MONTGOMERY COUNTY HISTORIC PRESERVATION COMMISSION
STAFF REPORT

Address:	8 Primrose Street, Chevy Chase	Meeting Date:	4/6/2022
Resource:	Contributing Resource Chevy Chase Village Historic District	Report Date:	3/30/2022
Applicant:	Justin & Kimberly Shur	Public Notice:	3/23/2022
Review:	Historic Area Work Permit	Tax Credit:	Partial
Case Number:	984993	Staff:	Dan Bruechert
Proposal:	Building Addition, demolition, door replacement, and skylight installation

2 EX201 and EX202

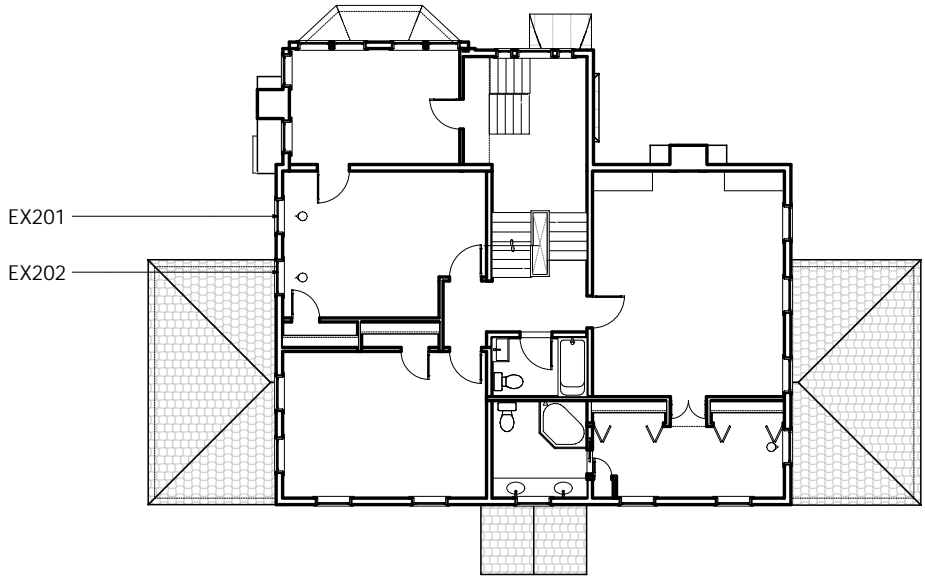
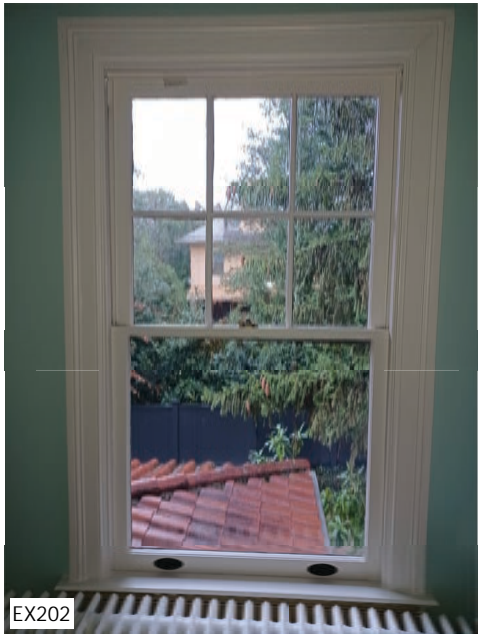
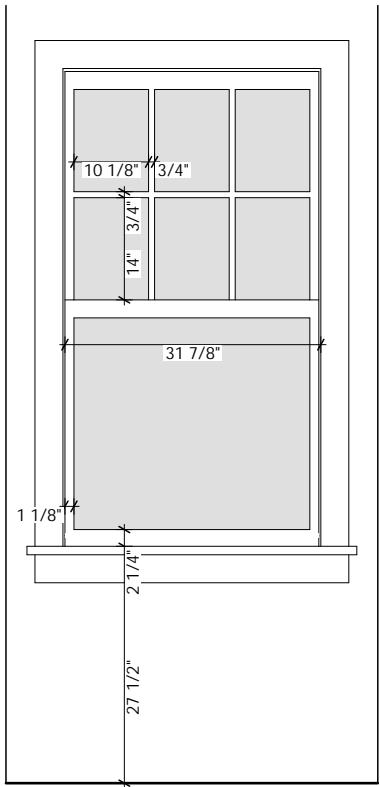
Based on the photographic evidence submitted, Staff finds the existing historic windows on the east elevation (labeled EX201 and EX202) appear to be in acceptable condition. As these windows are visible from the public right-of-way, their removal and replacement need to be reviewed under moderate scrutiny. Staff finds the proposed replacement window is an appropriately detailed wood window to be a compatible replacement for the historic windows at the subject property; the proposed windows match the dimensions and materials of the historic. The larger question is, whether it is appropriate to remove historic window openings and re-locate the openings. The historic house is a symmetrical design, five bays wide on the front and four bays deep on the sides. While removing one window opening on the east elevation and changing the window pattern, Staff finds that the proposal is acceptable on this elevation. Staff finds that while these two windows are visible from the public right-of-way (see Fig. 3), they are the third and fourth bay to the rear and are partially obscured by the porch roof. Because the windows are further removed from the streetscape with reduced visibility, Staff finds they are less significant than the windows closer to the front wall plane. Additionally, Staff finds that installing one window that matches the appearance of the historic and will not leave a blank wall plane and is an acceptable mitigating measure. Staff finds that with these windows removed and the new window installed, the house will still contribute to the district. Staff recommends the HPC approve the east window removal and replacement under the *Design Guidelines* and 234A-8(d).

1 EX 211
1/2" = 1'-0"

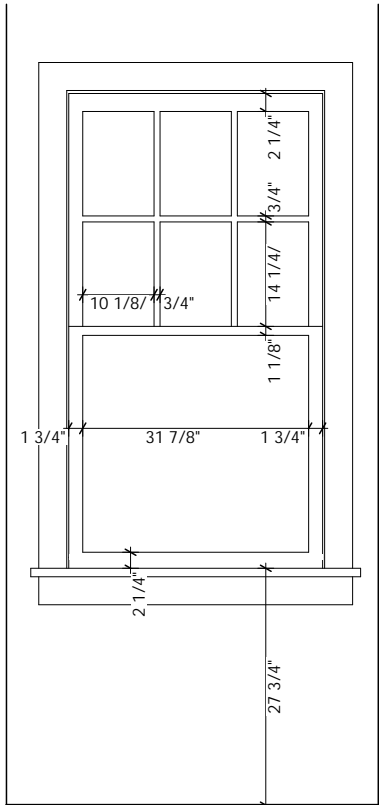
While Staff recommends approval for the window replacement on the east elevation, Staff cannot recommend approving the removal of the window on the west elevation, EX211, the window's shutters, and patching of the siding. Window EX211 appears to be in good working order and, it appears to Staff, that the window removal is driven entirely by changes to the interior plan. The proposal places a new sink and vanity in front of this window opening. Staff supports retaining this window for several reasons. Staff notes that proposed changes in the Chevy Chase Village are to be evaluated on how they are viewed from the right-of-way. This requires a stricter application of the approval criteria closer to the front of the house. First, because this window is closer to the front of the house, a large section of stucco at the front corner will disrupt the even window spacing on the right elevation (see the elevation drawings below). Second, Staff finds that removing the window and shutters will disrupt the even window spacing on the right elevation and negatively impact the house's design integrity. Under a moderate scrutiny review, the HPC needs to take preserving the integrity of the resource into consideration. Staff finds that the window and shutters are both original to the house construction and their removal would negatively impact the house's design and material integrity. Staff acknowledges that the house would likely still contribute to the surrounding streetscape; however, the change is not compatible with the original design of the house. Staff finds the removal of window (EX211) does not satisfy the requirements of "Moderate Scrutiny" in the *Design Guidelines* and does not comply with 24A-8(b)(1) and (2). Staff recommends the HPC add a condition to the approval of this HAWP that retains window EX211 in place with the existing shutters. The HPC should delegate final approval authority to Staff to verify that this condition has been satisfied upon the applicant's submission of the final permit drawings.

1. Removing and patching the window on the second story on the west elevation (EX211) violates the *Design Guidelines* and 24A-8(b)(2) and the window needs to be retained as part of the house rehabilitation. Final approval authority to ensure the condition has been satisfied is delegated to Staff.
